V2500-A5/D5 SERIES PROPULSION SYSTEMS SERVICE BULLETIN

This document transmits the Revision 1 of Service Bulletin V2500-ENG-72-0614.

V2500-ENG-72-0614

ENGINE - HIGH PRESSURE (HP) COMPRESSOR - INTRODUCTION OF A NEW HP COMPRESSOR REAR SHAFT ASSEMBLY WITH A RING NUT THAT IS SILVER PLATED ON THREAD AND ABUTMENT FACE TO THE CUP WASHER ONLY

R Figure 1

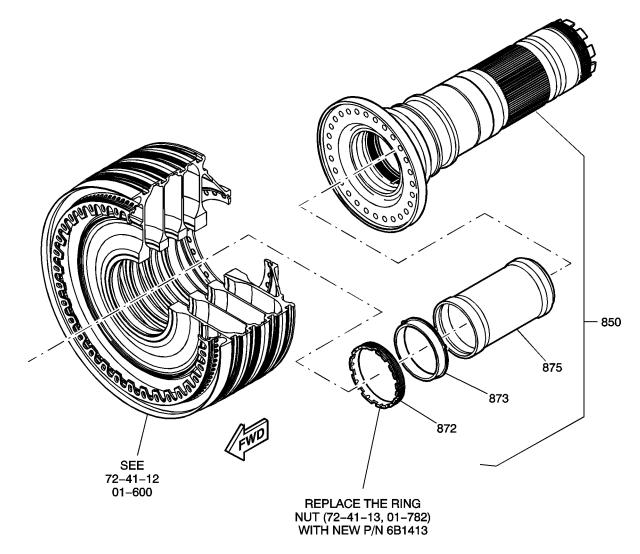
- (7) General Data
 - (a) This Rework Instruction gives the procedure to replace the ring nut located in the inner bore of the rear shaft. Part number UP10896 is to be replaced with new part number 6B1413.
 - (b) Material of components

R	(8)	Remove the Ring Nut			
R		(a) Refer to Fig.72-41-13-990-001 (Fig 901).		
		PROCEDURE	RELATED DA	TA	
R R R R R		(b) Remove the ring nut from the shaft assembly.	Remove the Ring	- Disassembly, UBTASKs therein.	
R	(9)	Replace the Ring Nut			
R		(a) Refer to Fig.72-41-13-990-001 (Fig 901).			
		PROCEDURE	RELATED DA	TA	
R R R R R R		(b) Fit new ring nut 6B1413 into the shaft assembly.	the HP Compresso Assembly, accomp therein. Install the new	lish all SUBTASKs Ring Nut (72-41-13, ber 6B1413. Ensure	
R	(10)	Identify the Rework			
		PROCEDURE	RELATED DA	TA	
R R R		(a) Cancel the existing part number and re-identify the HP Compressor Rear Shaft Assy.	Refer to SPP TAS Use Vibro-engrav Existing	K 70-09-00-400-001. ing equipment. Re-number	
R R			6A7713 6A7711	6B1426 6B1419
